**ADDENDUM NO. 1
NEW ELEVATOR
AT MURPHY ELEMENTARY SCHOOL
ROUND LAKE SCHOOL DISTRICT NO. 116
PROJECT NO. 23170**

Board of Education
Round Lake School District 116
884 West Nippersink Road
Round Lake, Illinois 60073

2 PARTIAL FIRST FLOOR PLAN
1/4" = 1'-0"

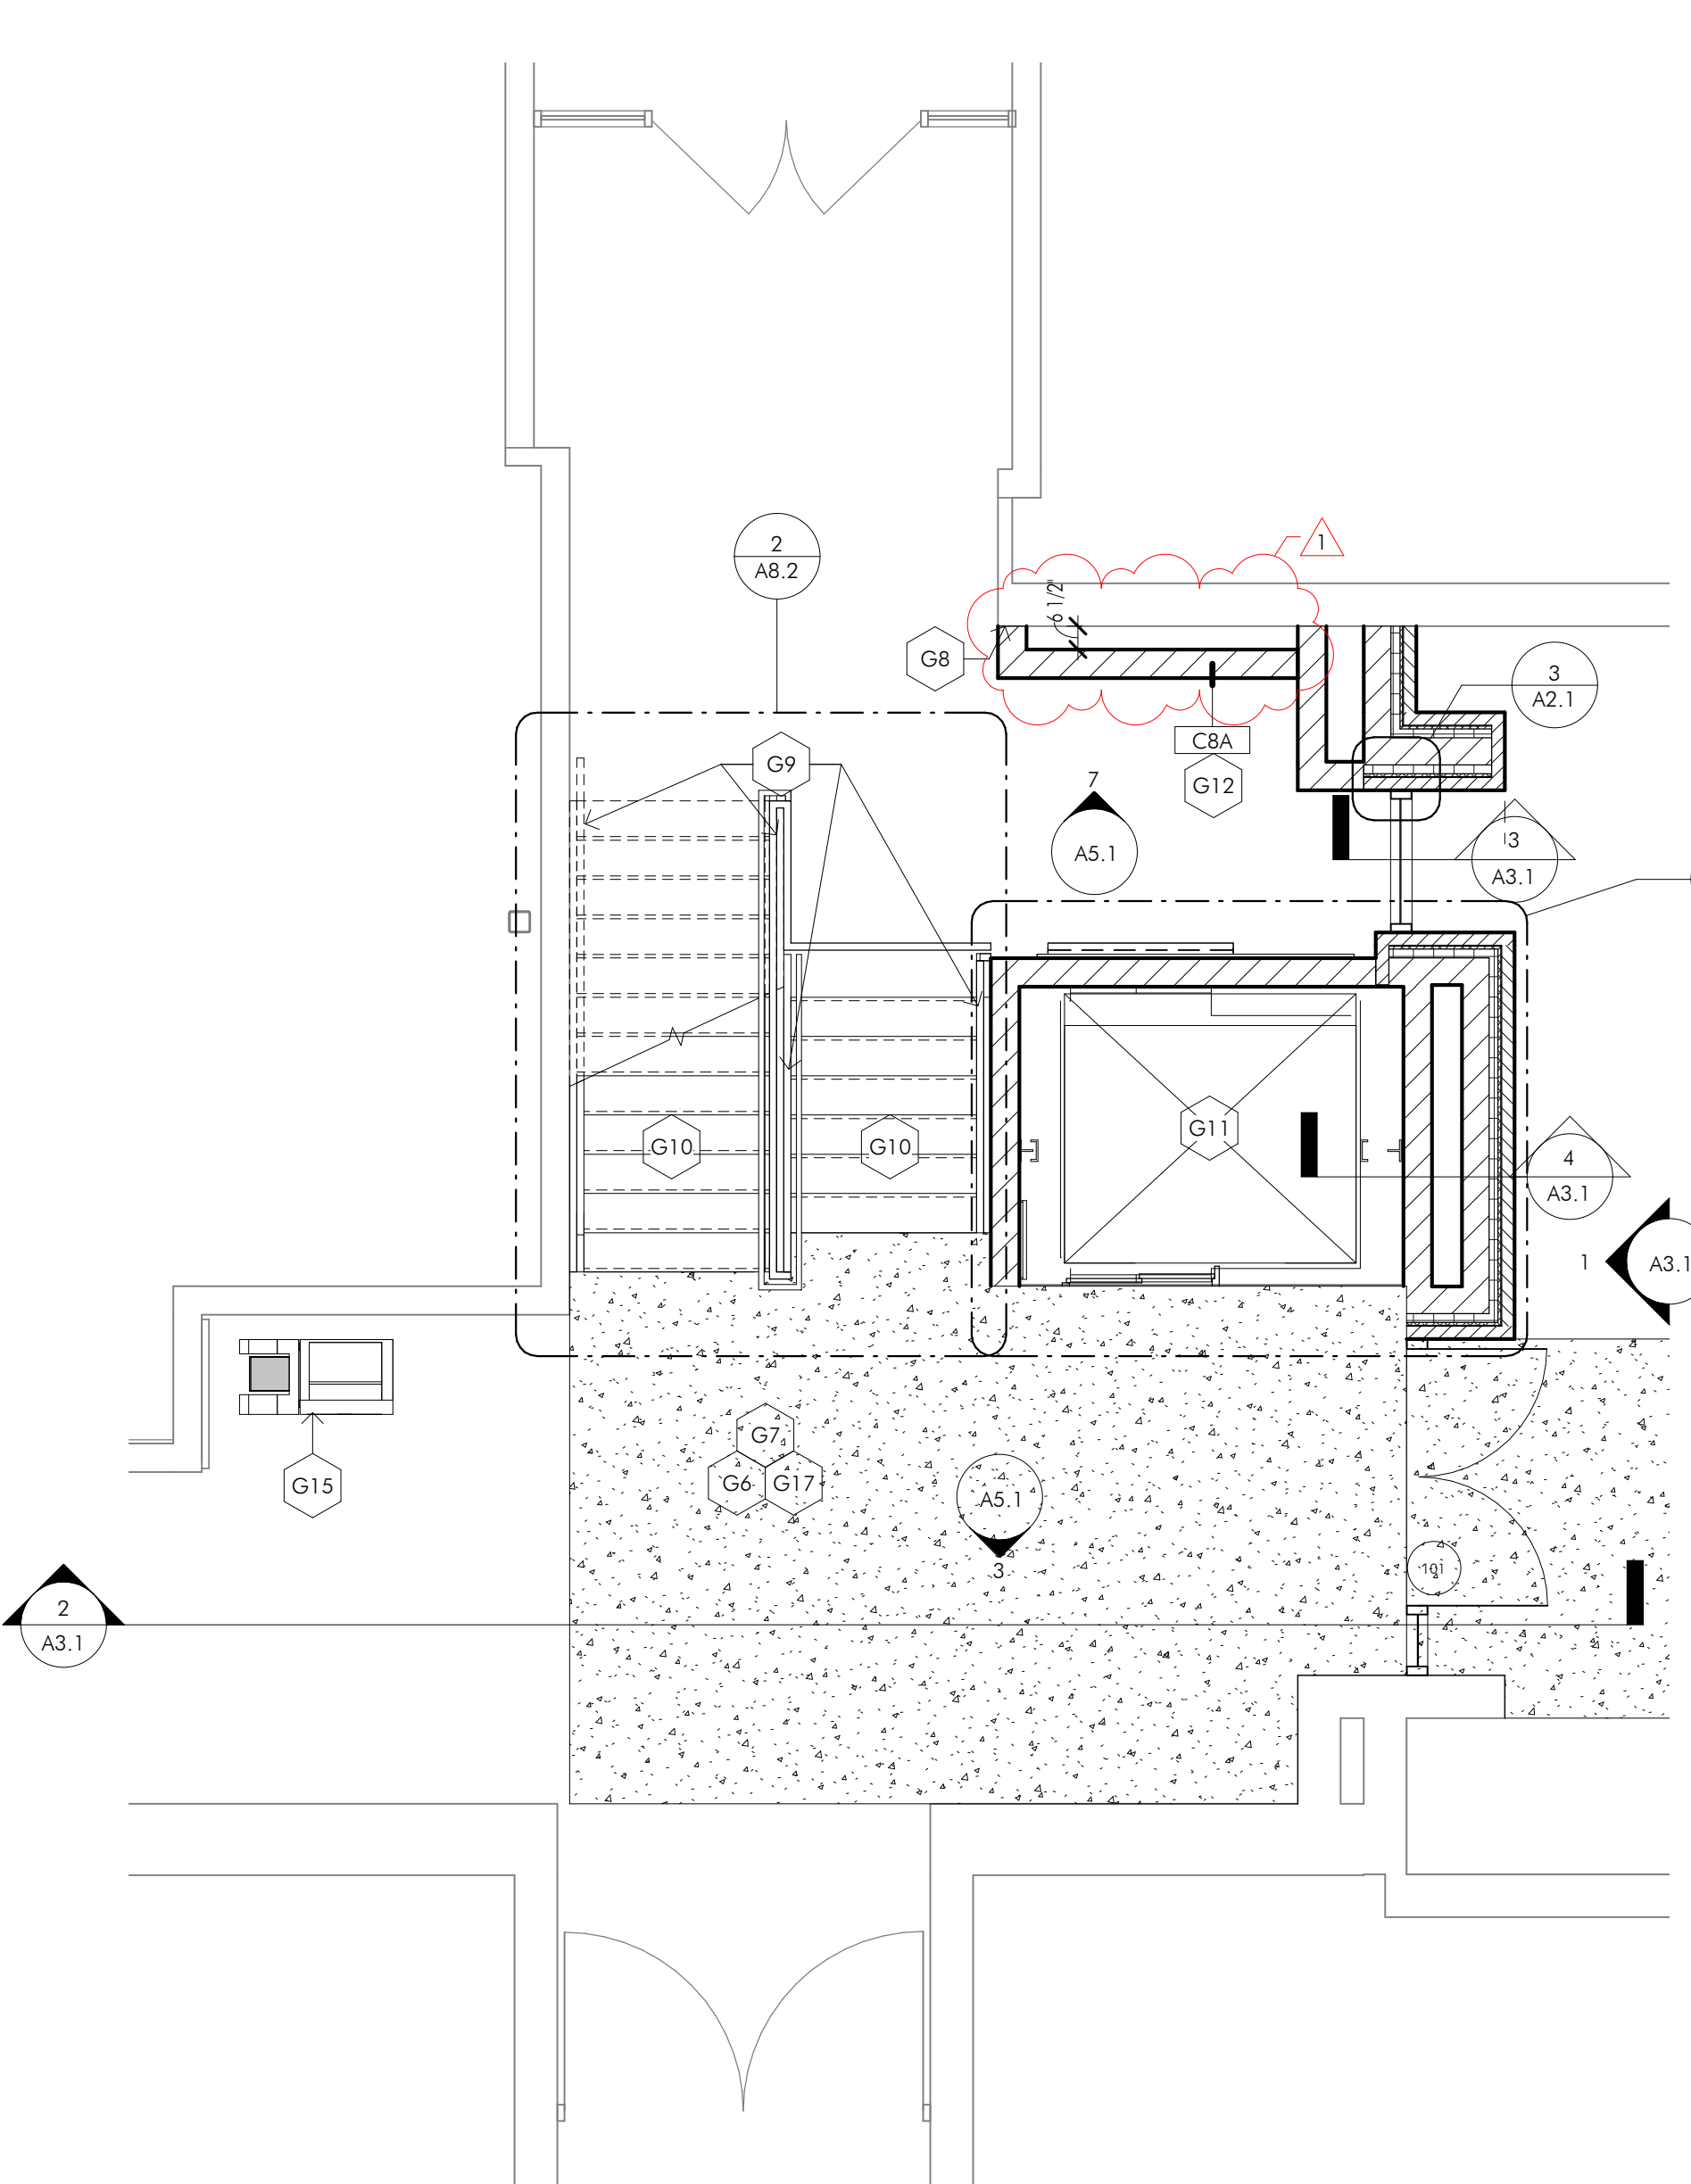
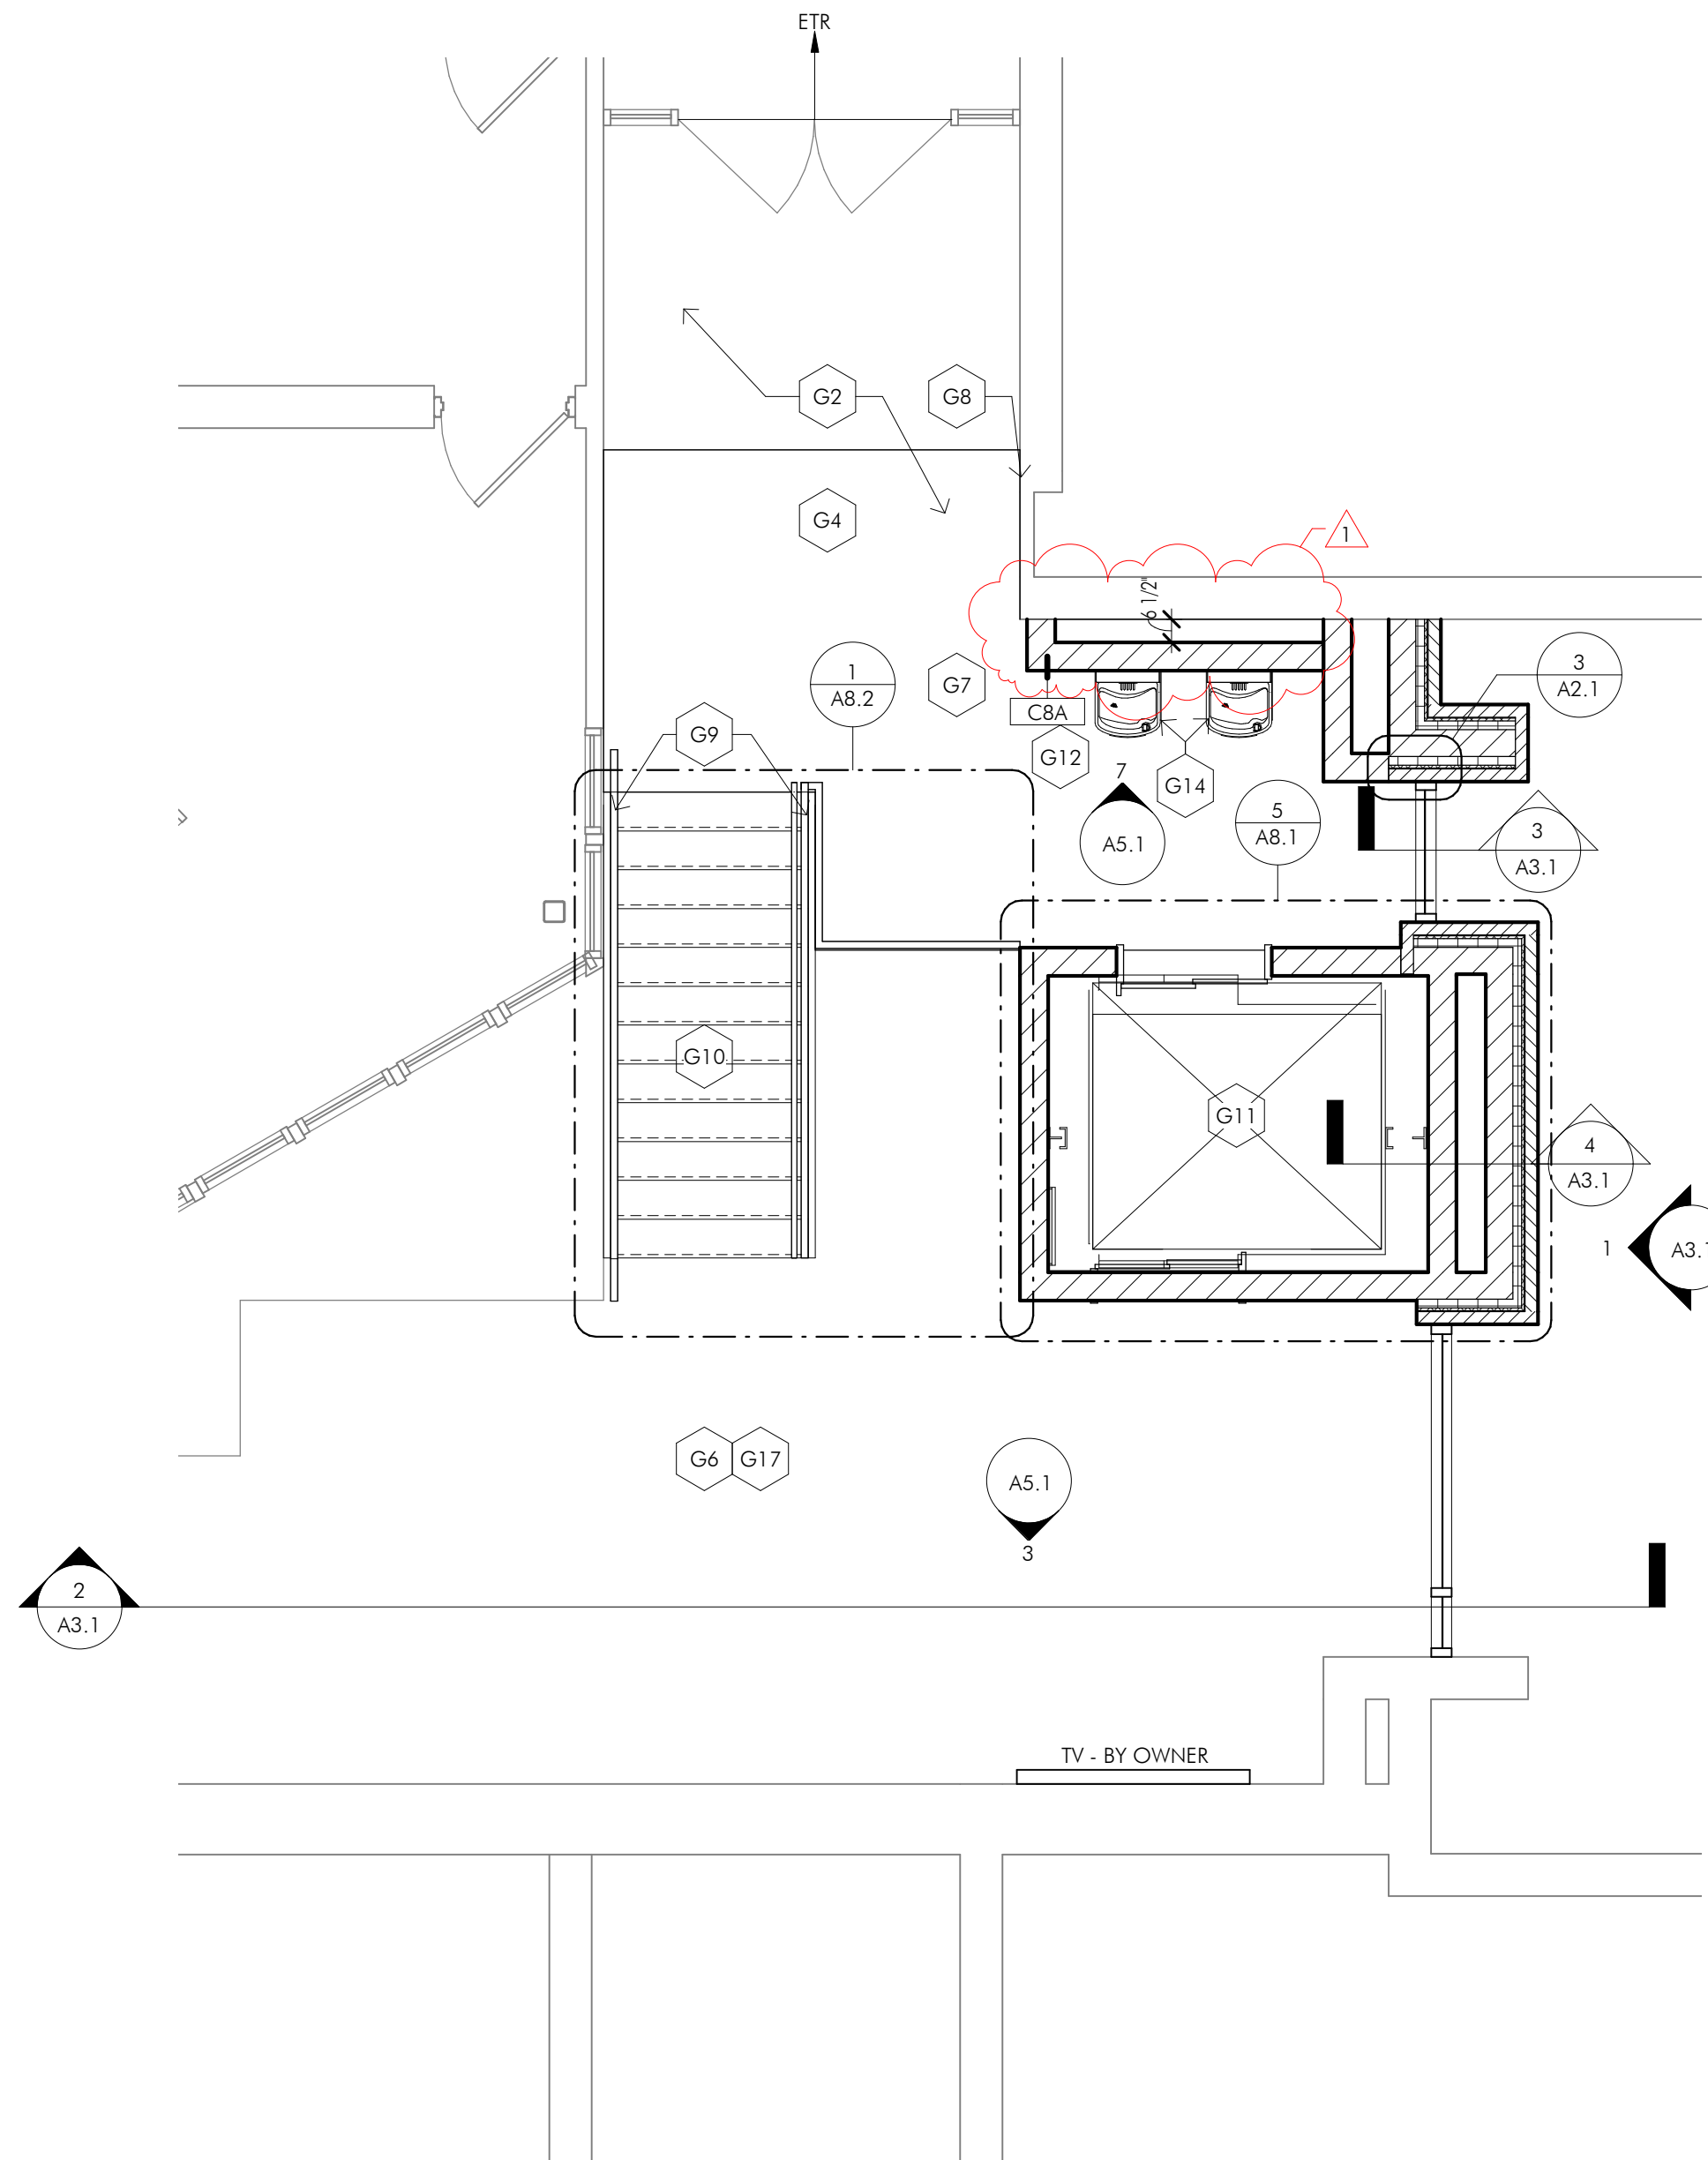
ITEM NO. 3: DRAWINGS, SHEET A1.1

1. Revised plumbing wall location.
